**World Forum for Harmonization of Vehicle Regulations****Working Party on Brakes and Running Gear****Eighty-fourth session**

**Regulations Nos. 13 and 13-H: Clarifications****Proposal for amendments to Regulation No. 13 (Heavy vehicle braking)****Submitted by the experts from France and Germany\***

Figure 5A  
**Mechanical-transmission braking system**  
 (See paragraph 2.3. of this annex)

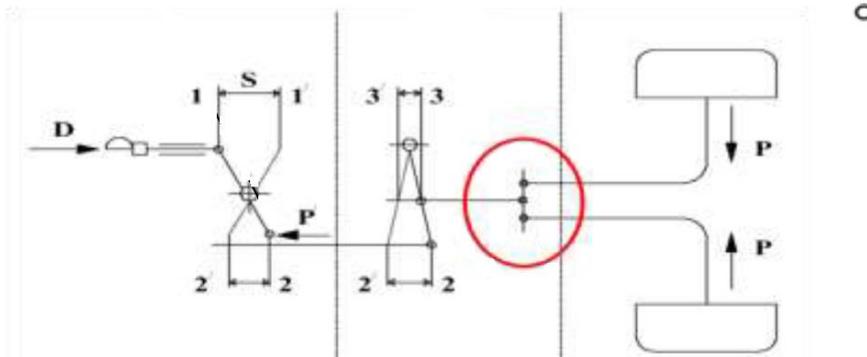
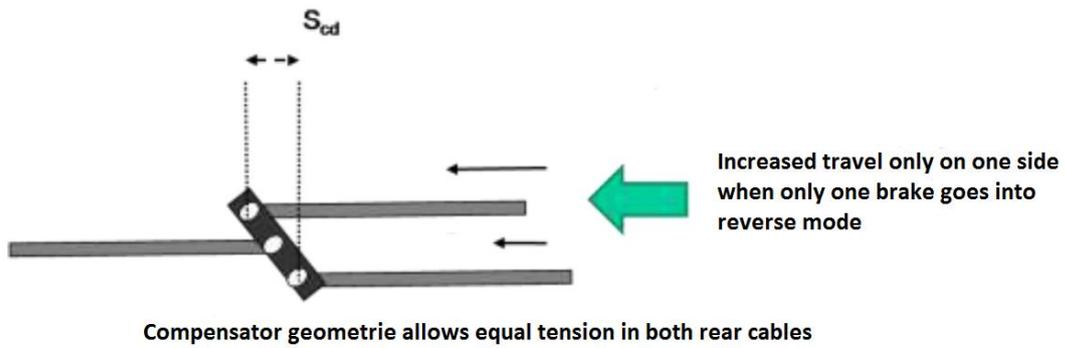
Annex 12, Appendix 1, Figure 5A, amend to read:

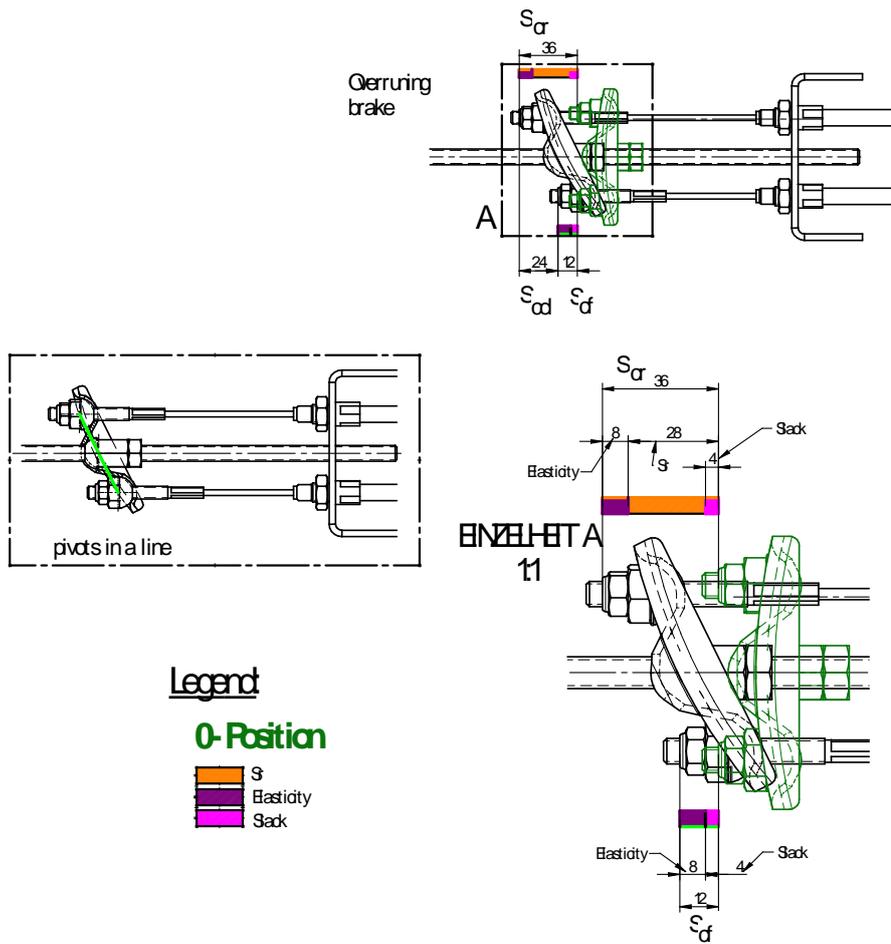
14. A reason for this may lie in the circumstance that  $s_B$  and  $s_r$  have different preconditions as to the actuation force they occur under. While the condition for  $s_B \times i_g$  the actuation force to reach the prescribed deceleration ( $0.49g \times G$ ) is conceived it is only the actuation force to reach max.  $0.08g \times G$  to reverse in case of  $s_r$ .

15. In a situation where the parking brake is applied ( $0.18g \times G$ ) we have yet different actuation forces. The illustration below shows a practical example of the situation at the compensator:

17. The illustration above suggests equal tension in both cables and as such equal travel due to elasticity, thus  $s_{cd} \geq 1.2 (s_r - \text{slack})$ . Determining the slack is extra effort, subject to measuring tolerances and assumed to be not very big. Therefore the plead is to waive it, consider it an extra safety margin and say  $s_{cd} \geq 1.2 \times s_r$ .
